Number	G9-2
Score	216 / 487
Rank	11位

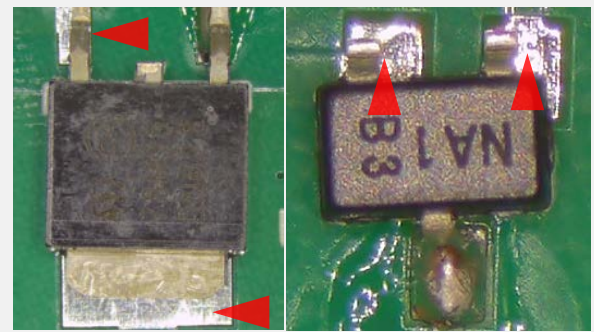
取付方向相違
IPC-A-610G 7.1.1.1を参照

はんだ不足
IPC-A-610G 8.3.14, 8.3.5を参照

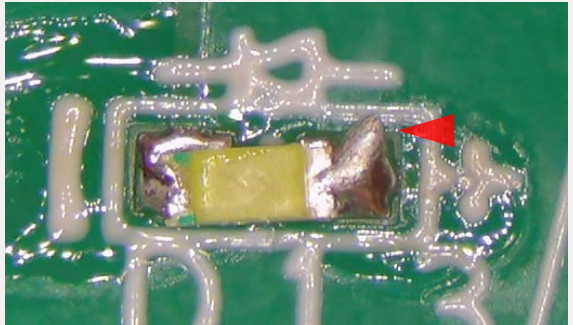
はんだ過多
IPC-A-610G 8.3.2を参照

FOD
IPC-A-610G 10.6.2を参照
